Environmental Services - Water Quality
Onsite Wastewater Scan Data Entry Form

WAKE COUNTY ENVIRONMENTAL HEALTH WELL AND SEWAGE SITE LOCATION PERMIT

Attached please find two copies of our proposal for a Low Pressure Pipe on-site sewage disposal system for:
Lot 32, Weaver Crossing D-5422

ALTERNATIVE SYSTEM DESIGN
date: 9-25-97

Construction
 Authorization
 Race Site Plan

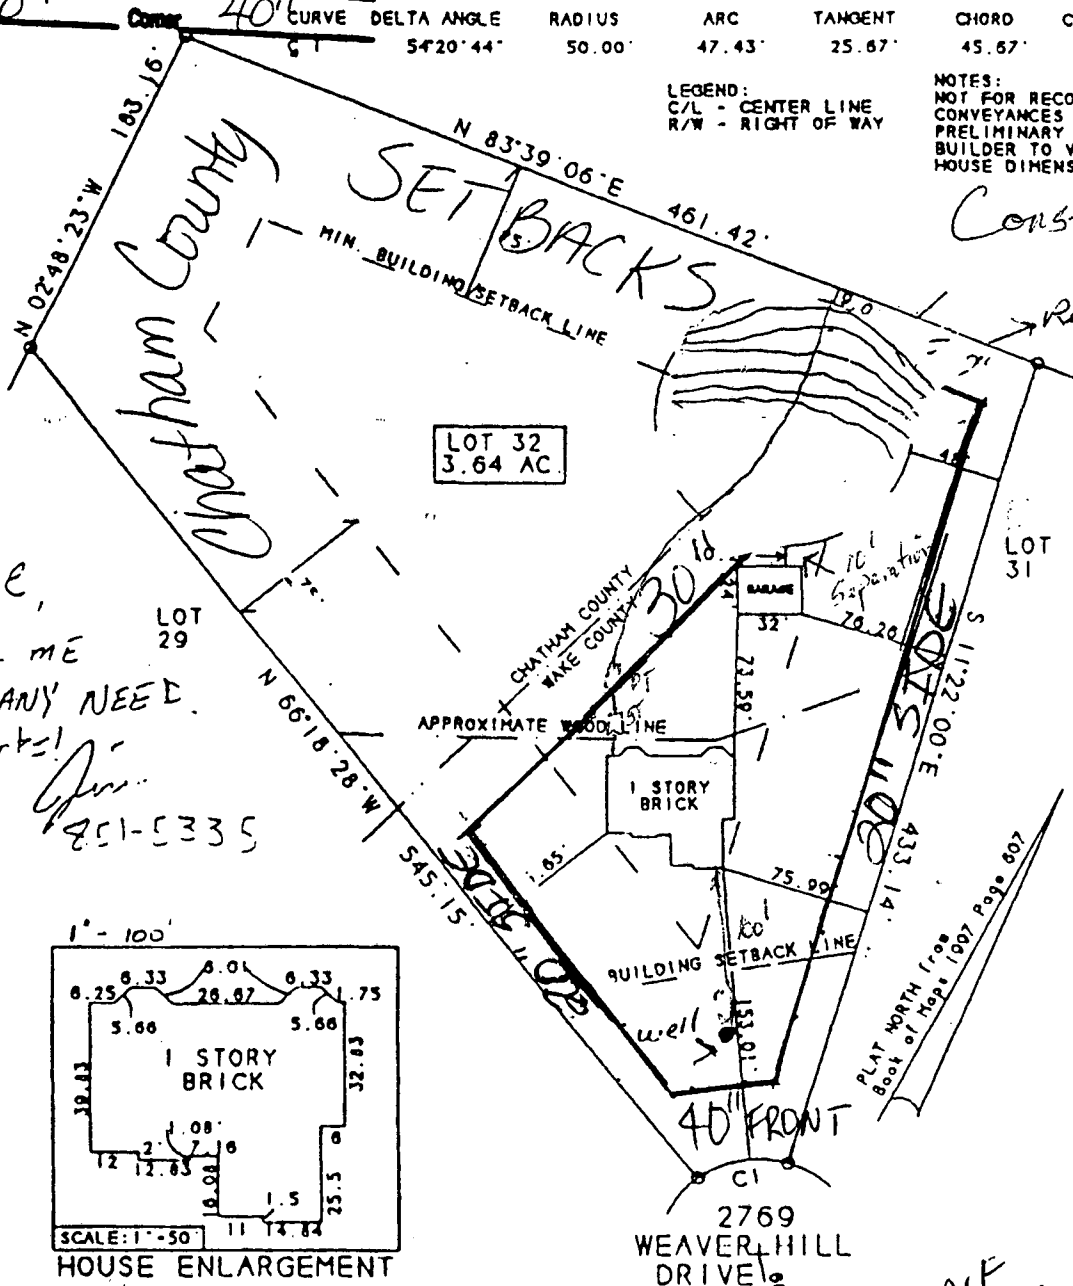
*NOTE: LPP PERMIT
Install according to plans
Detached garage must be
at least 10' from repair
area.

Contractor To Follow Contours, See Attached Site Plan For Wastewater System Design And Well Location
